Subject : DG3 report with redline on

Decision Gate 3**Review of the Muskrat Falls and
Labrador Island HVdc Link
and the Isolated Island Options****FINAL DRAFT**

Manitoba Hydro International Ltd.
211 Commerce Drive
Winnipeg, Manitoba R3P 1A3, Canada
www.mhi.caSeptember ~~4~~¹⁸, 2012

Figure 9: Design Spans for Climatic Ice Loading Loads along the HVdc Transmission Line Route compared to the CSA Standard 1:500-year return period limit

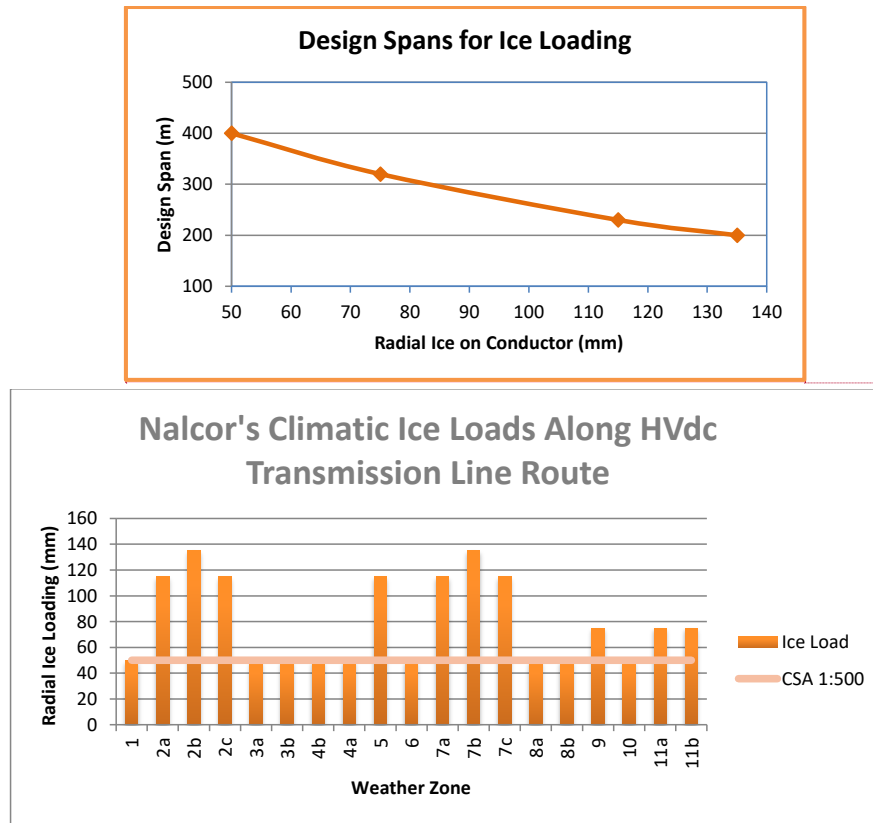
Commented [plw12]: Gerry, I count 19 in the chart below.

Commented [plw13]: Add 1:50 and 1:150 design criteria on this graph???
